<b>Notice of Allowability</b>	Application No.	Applicant(s)	
	10/631,055	FROMMER ET AL.	
	Examiner	Art Unit	
	Kevin P. Rizzuto	2183

### EXAMINER'S AMENDMENT/COMMENT

Figure 1

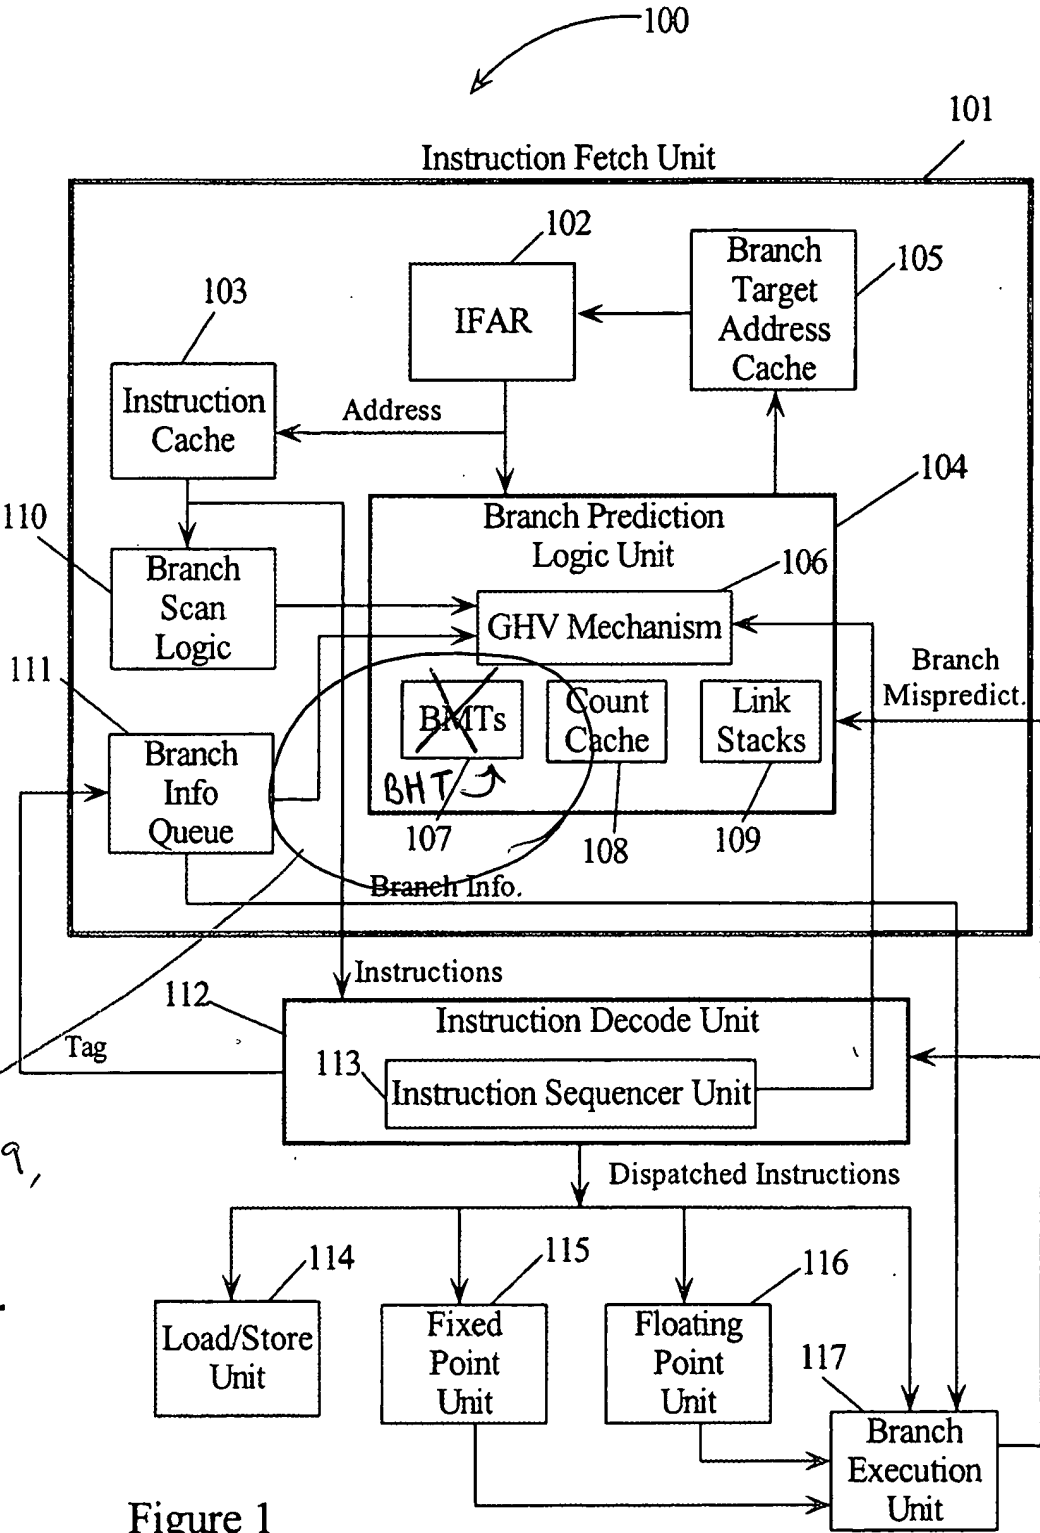
1. Claims 1-20 are allowed.
2. The following changes to the drawings are required: Fig. 1, Branch History Tables (BHTs) 107 is depicted in the drawings as "BMTs" 107. Appropriate correction, that is, changing "BMTs" to "BHTs", is required. See attached annotated drawings for further clarification. For further information, see also MPEP 608.02(w) – 608.02(z).

See page 9,  
line 7 of  
Specification.
